Bubble Plan v11: the builder's take

South front door, big open lobby, safe kids wing, offices in a modular to start. Laid out the way a church architect would.

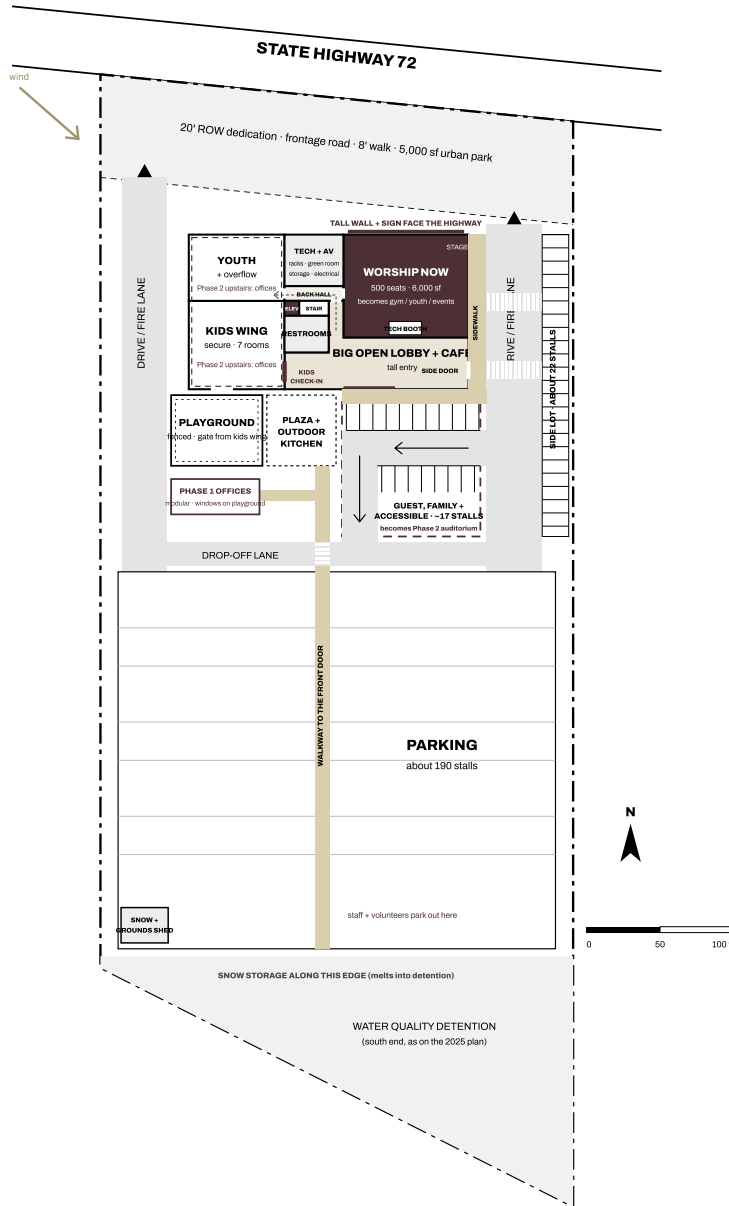
1. **Grow by adding a room, not stretching one.** Making a worship room bigger means tearing out the stage wall, the most expensive wall in the building. Phase 2 builds a new auditorium off the lobby. Today's room becomes the gym, youth, and event space.

2. **Face the highway.** In v4 the highway saw the back of the building and an empty lot. Now the tall worship wall and sign face Highway 72. That also fits the city's frontage rule.

3. **Playground at the kids door.** No long fenced walk past the drive. Kids go out one gate.
4. **Parking closer to the door.** Guests, families, and accessible parking go on the Phase 2 pad, right at the front door. Cars enter from the east drive and exit onto the drop-off lane. A side lot runs along the east wall. Staff and volunteers park in the far rows. About 230 stalls in Phase 1.

5. **Tall where it counts.** A tall entry and a high ceiling in the lobby, not a full-height box. Same feel, lower heating, cooling, and steel cost.
6. **HVAC on the roof, not over the worship room.** It's a steel building, so the units go up top. Set them over the lobby and back of house. Over the worship room they add noise and need heavier steel.

7. **Every room needs a way in.** A back hall runs from the lobby to youth, the tech room, and the stage. The lobby wraps the front so families reach kids check-in without passing the restrooms. A side door on the east wall serves the side lot.

8. **Clear walking routes.** One walkway runs straight through the main lot to the front door. Side-lot parkers cross at two crosswalks to a sidewalk along the building. A shed holds the plow and ice melt, and snow piles go by the detention area.

If today's room becomes the gym later, it wants a **flat floor**. That means a raised stage and stepped seating in the back, not a full Journey Church slope. The full slope moves to the Phase 2 auditorium.

1. **Frontage rule:** does this setback satisfy MX-S?
2. **Lot size:** 4.96 or 5.39 acres, and does the 20 ft right-of-way come out of it?
3. **Parking:** how many stalls does Arvada require for 500 seats now and about 700 later?
4. **Phasing:** can one site plan approve Phase 2 and the second floor now?
5. **Modular offices:** allowed on site for a few years? Permits, utilities, rough cost?
6. **Upstairs:** does a second floor need a second stair? Build the elevator shaft now or later?
7. **Height:** the lot allows 45 ft. Does a tall worship room fit?
